LIVING WITH HISTORY

## Certificate of Appropriateness

**1003 N. 33RD ST. Concordia Historic District**

PTS ID 89229 COA, total exterior restoration

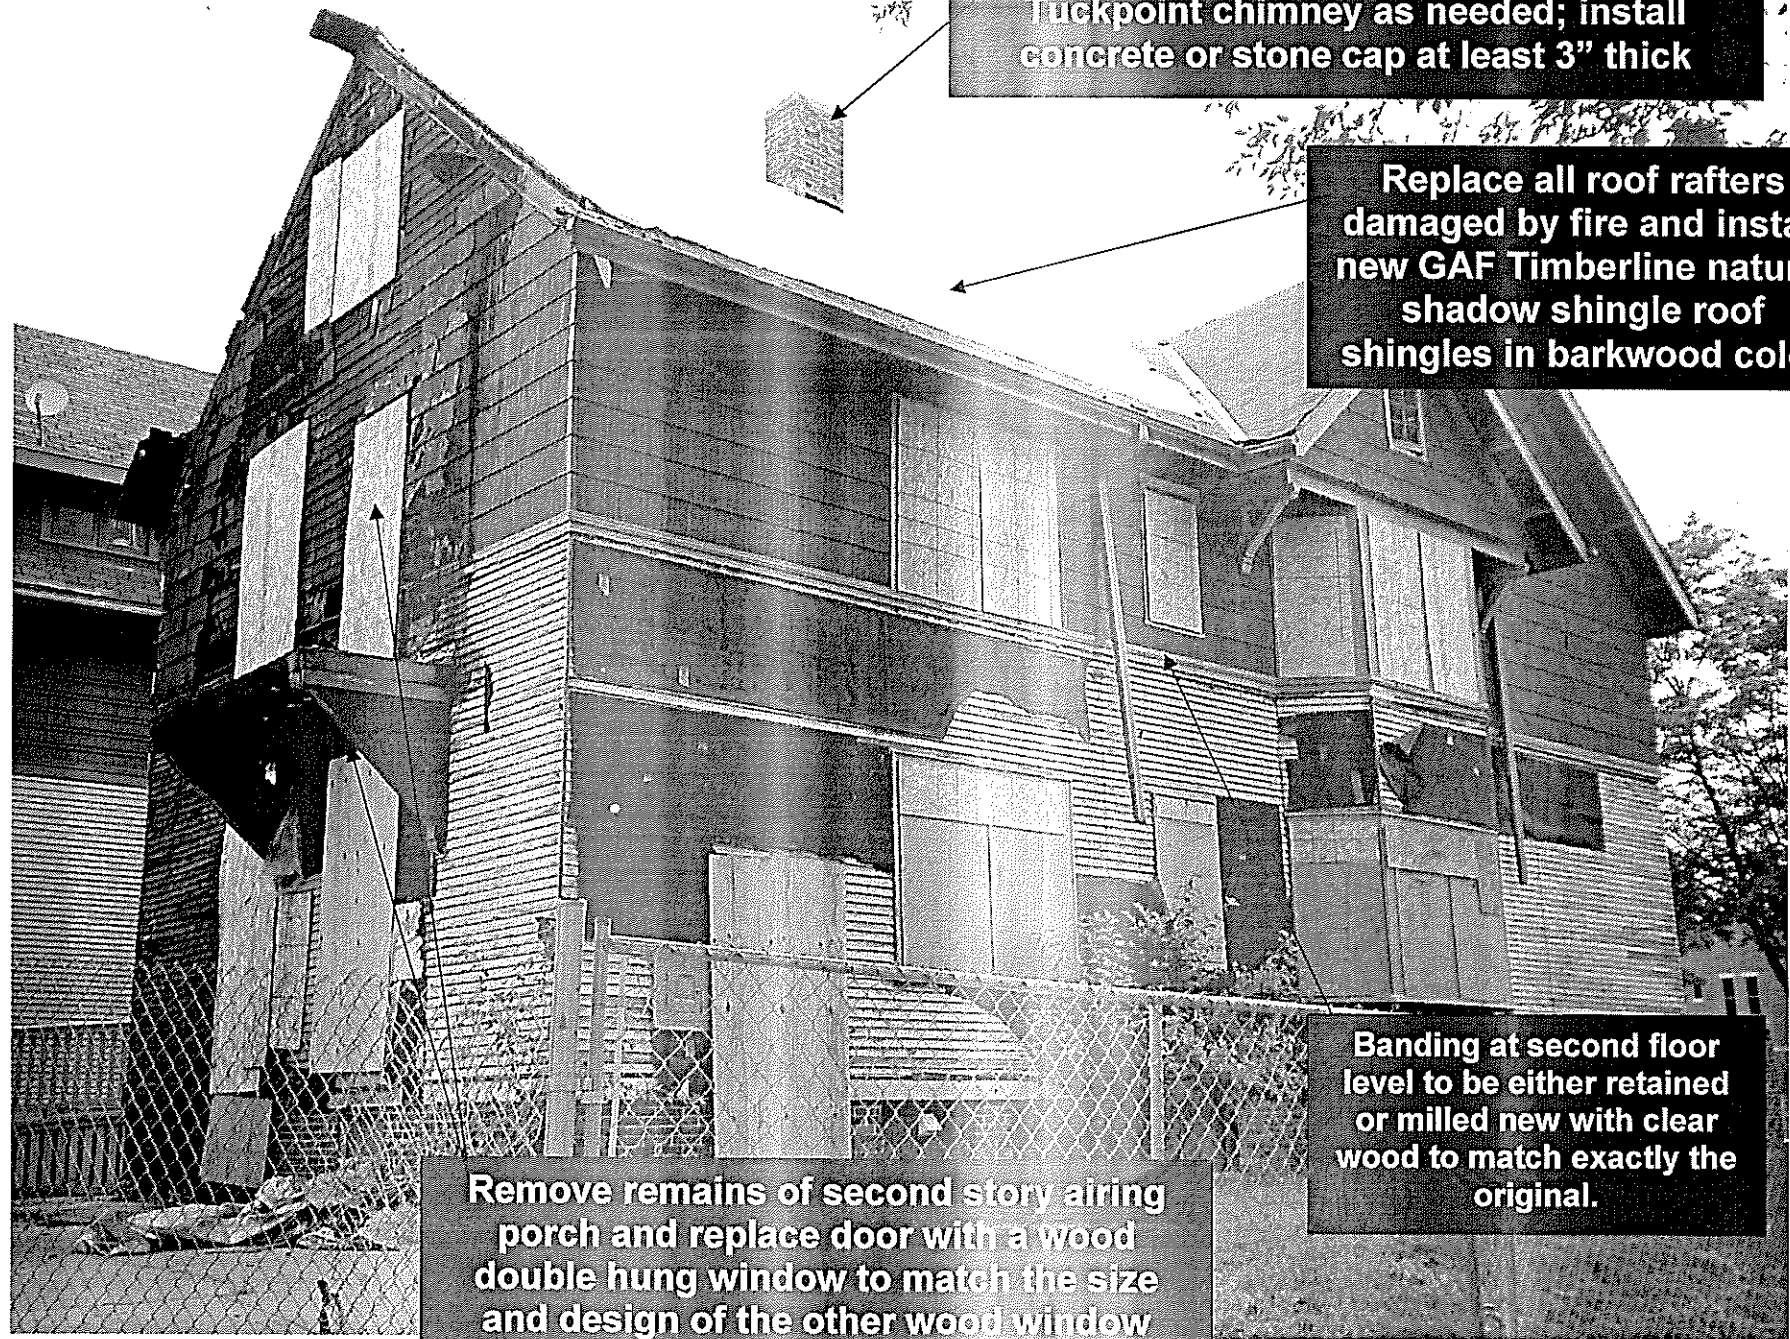
**Vertical grain wood shingles to be installed on upper stories with every fifth course double thickness**

**Dormer removed due to fire. Will not be rebuilt.**

**Siding to be replaced with new, vertical grain, radially sawn smooth wood clapboards to match the original. Vertical wood corner boards will be used at outside corners on first story**

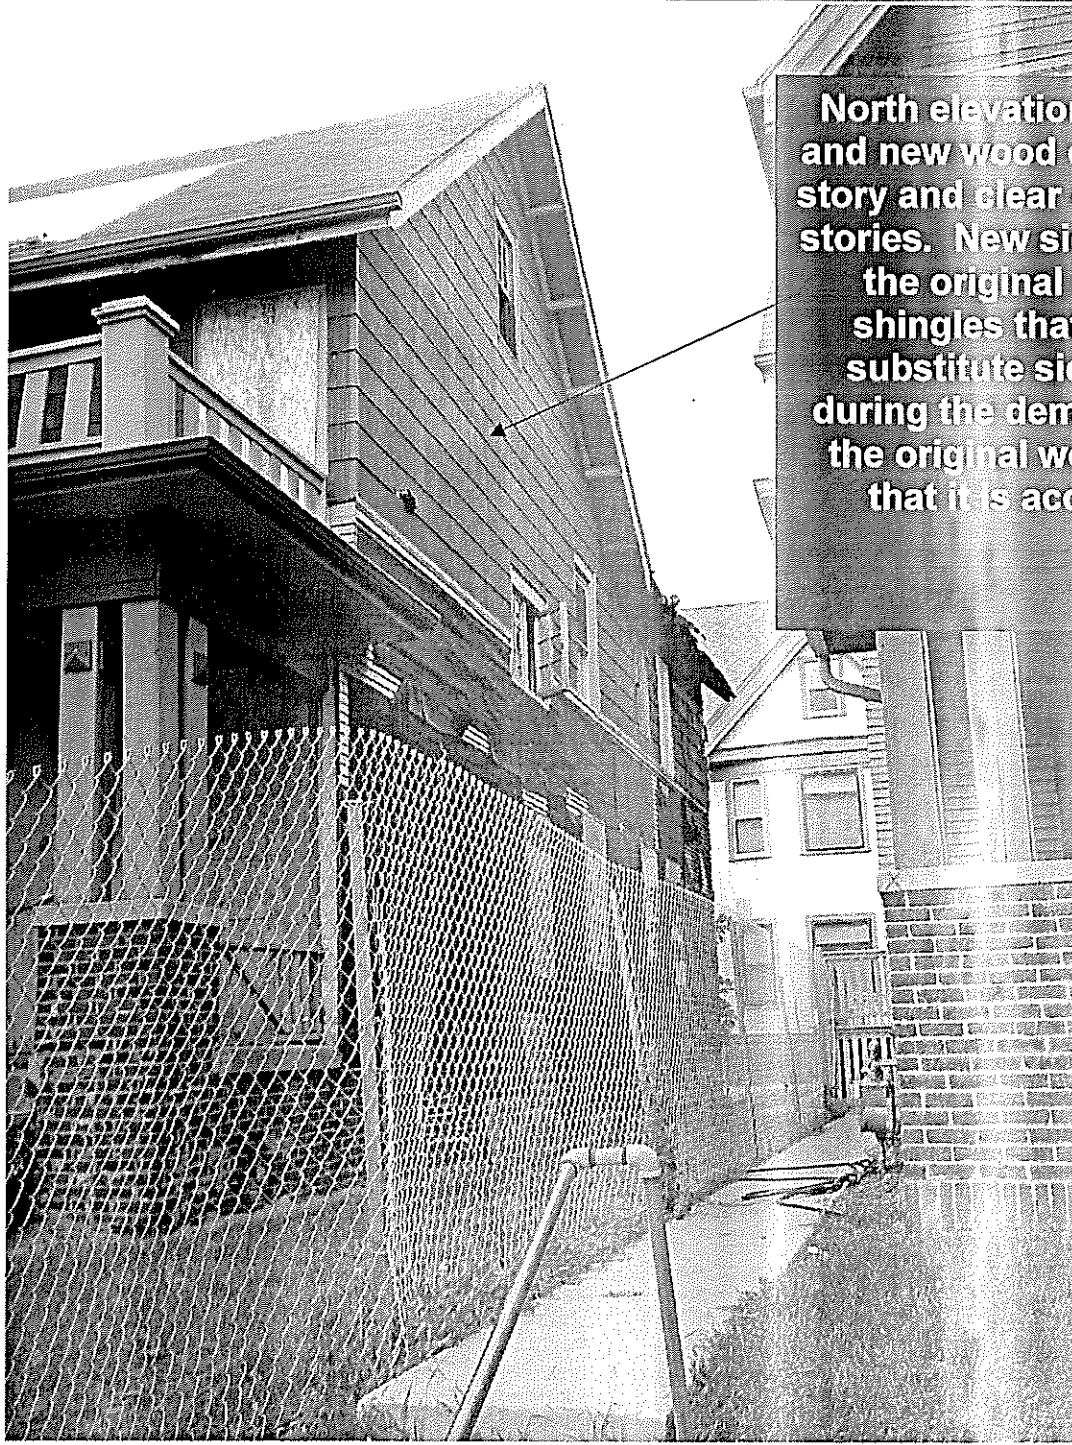
**Tuckpoint chimney as needed; install concrete or stone cap at least 3" thick**

**Replace all roof rafters damaged by fire and install new GAF Timberline natural shadow shingle roof shingles in barkwood color**

**Remove remains of second story airing porch and replace door with a wood double hung window to match the size and design of the other wood window next to it**

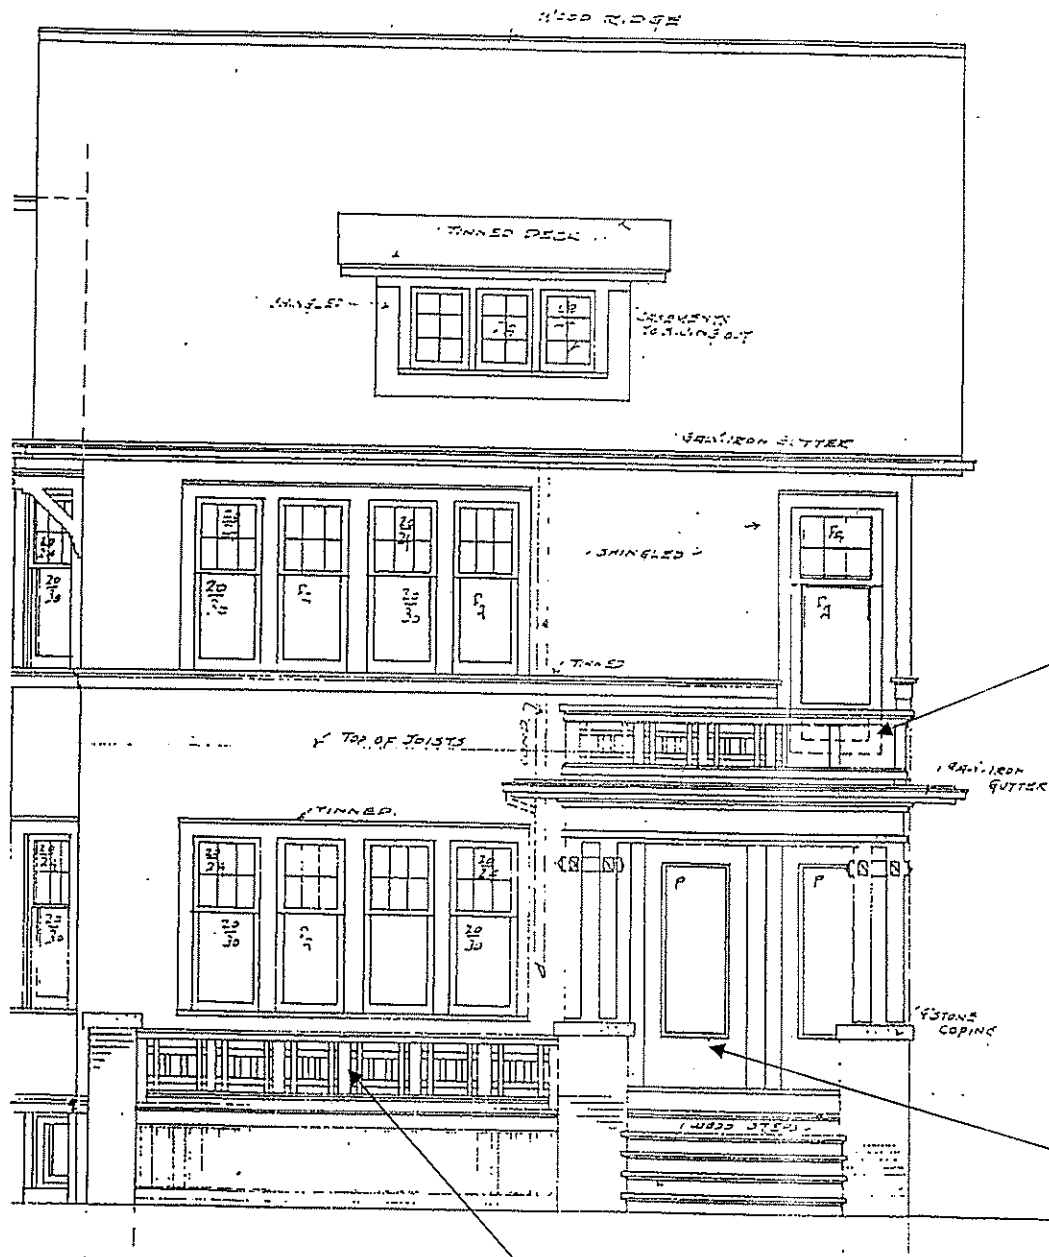
**Banding at second floor level to be either retained or milled new with clear wood to match exactly the original.**

**North elevation. All siding to be stripped and new wood clapboards installed on first story and clear cedar shingles on the upper stories. New sidewall shingles must match the original exposure of the existing shingles that are now underneath the substitute siding. Care must be taken during the demolition to note all details of the original wood shingle installation so that it is accurately rebuilt with new materials.**

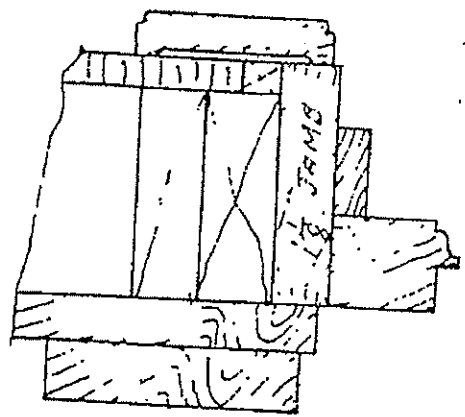
Restoration to match architect's original drawings with the exception that the front dormer will not be rebuilt.

Second story guardrail to be rebuilt to the original design but at 36" in height above deck

All window openings with true original divided lite top sash must be replaced with true divided lite wood sash.

Front doors to match original design. If a storm door is desired, it must be made of wood and be "full view" in design.

Guardrail on first story to be rebuilt to original height pending DNS approval

TYPICAL  
CASEMENT WINDOW  
DETAILS (3" SCALE)

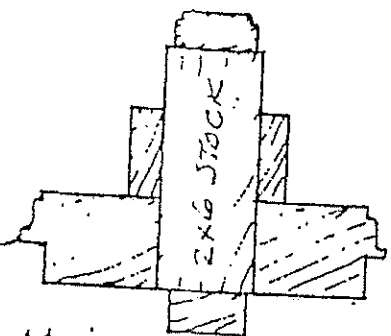
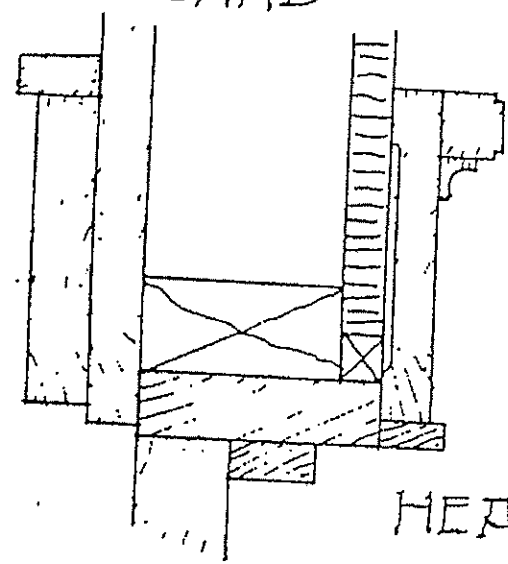
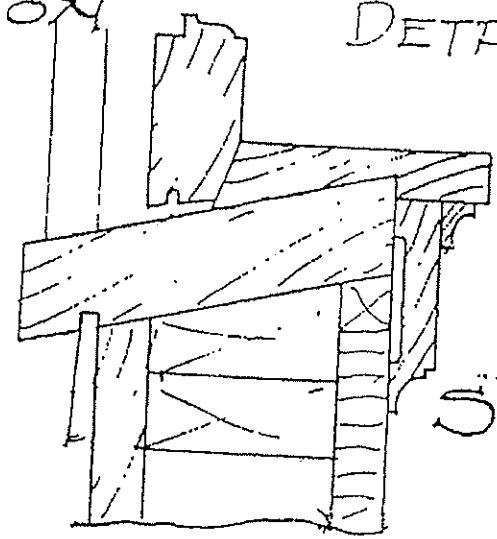
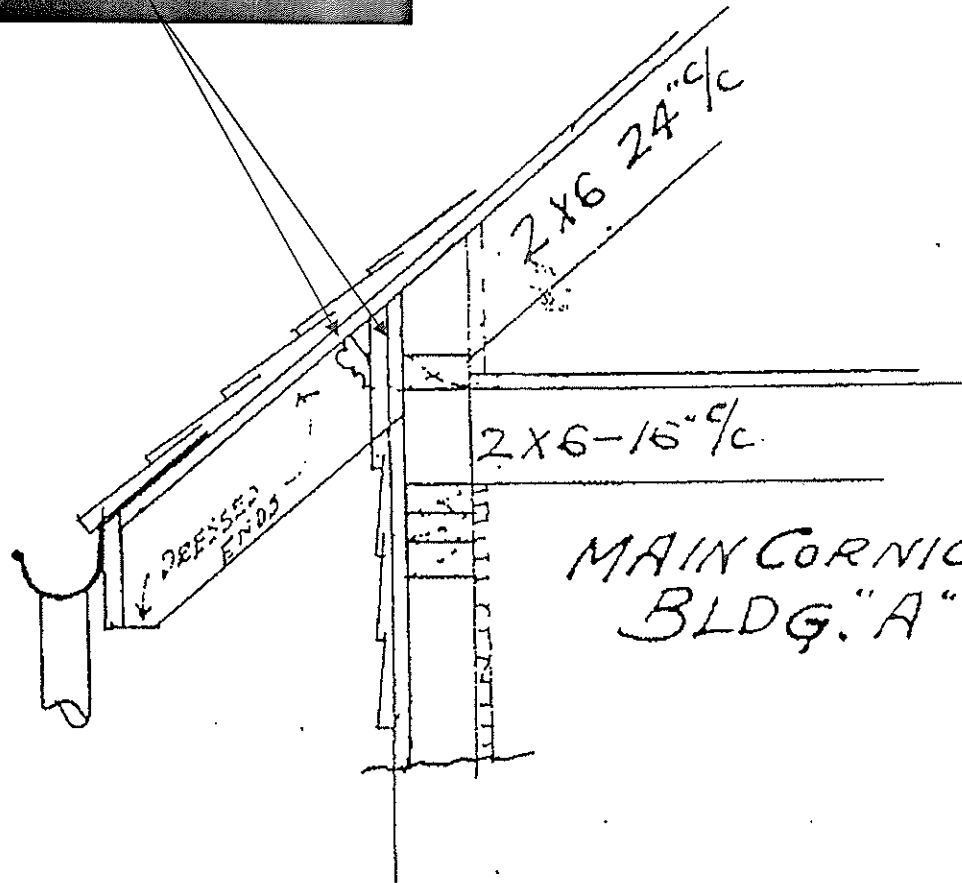
Architect's original details for sash must be followed exactly. These are for the casement windows and are specifically related to windows on the north elevation

MAIN CORNICE DETAIL  
BLDG. "A" (BLDG. "B" SIMILAR.)

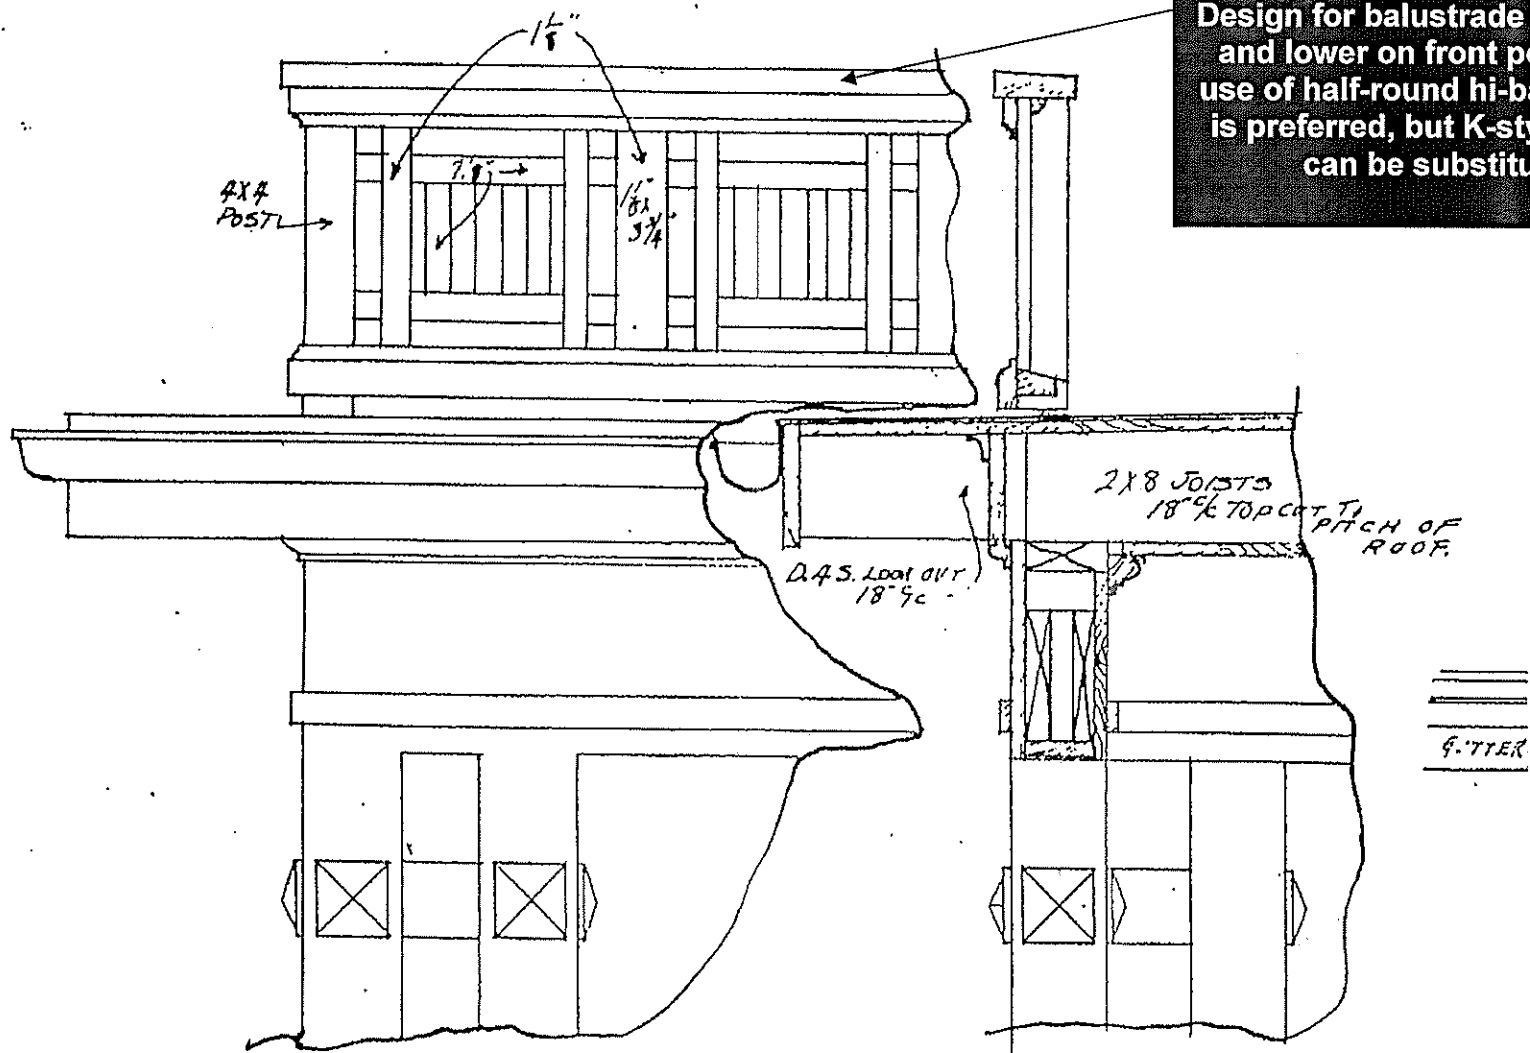
Typical wall section. Note that the flat frieze board at the top of the wall must be installed and that there is crown molding between each rafter tail.

PORCH CORNICE FOR BLDG. "A"

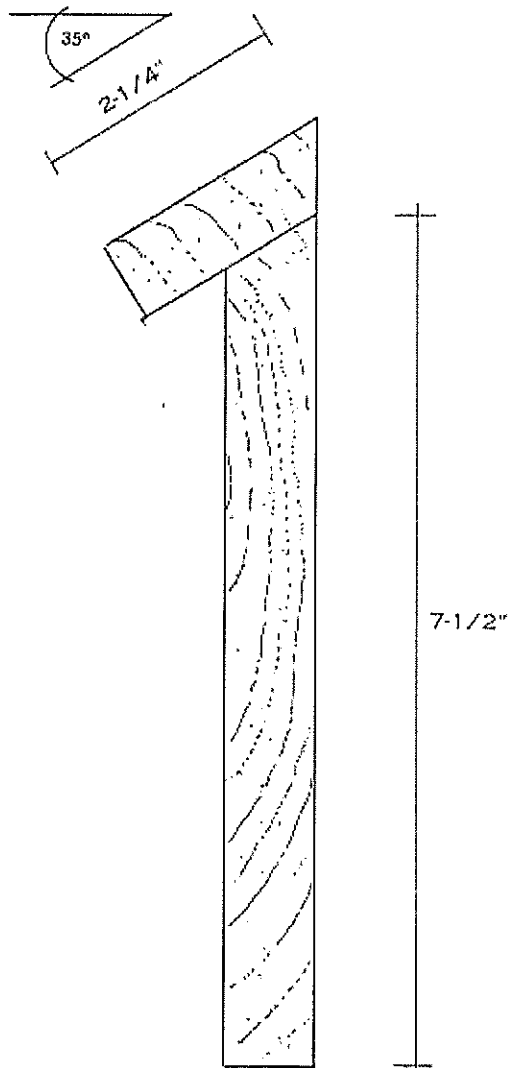
Design for balustrade both upper and lower on front porch. The use of half-round hi-back gutters is preferred, but K-style gutters can be substituted.

Front porch will be repaired/; rebuilt to original specifications and design

WATER TABLE

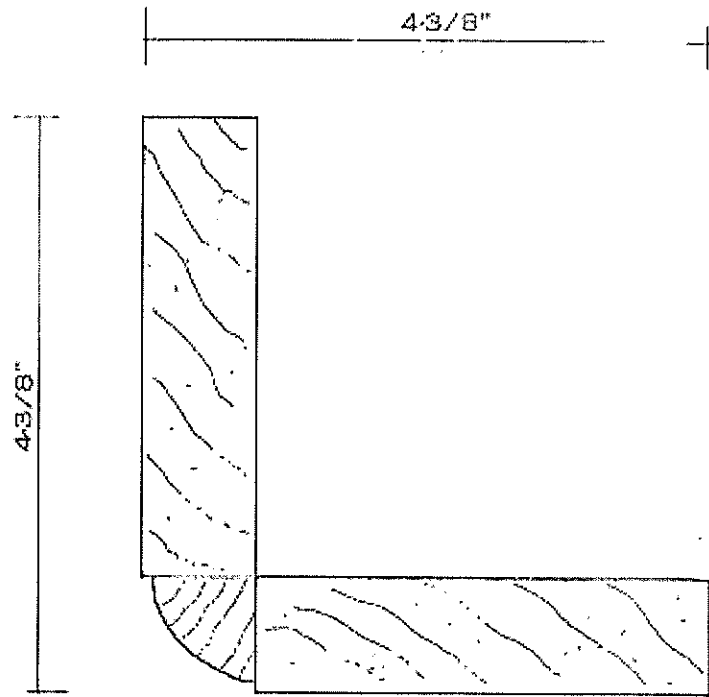
**Section of water table that will be installed at the top of the raised foundation around the entire perimeter of the house.**

### CORNER BOARDS

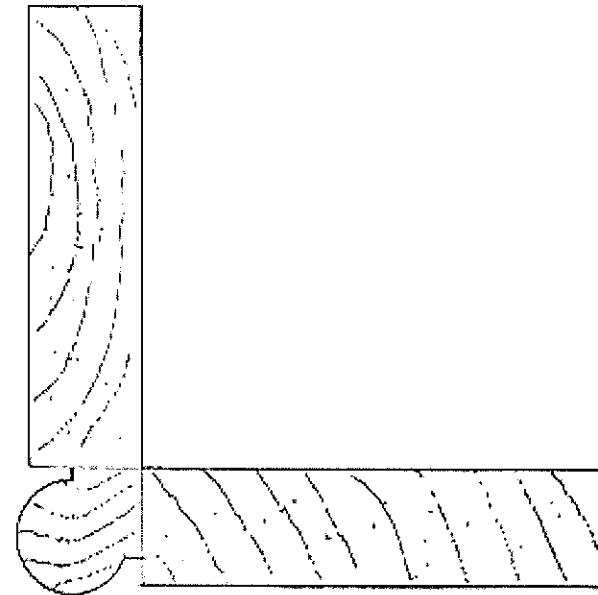
Corner board details for first story only. Either design is permissible, but option B is regarded as the easiest to install using stock corner bead.
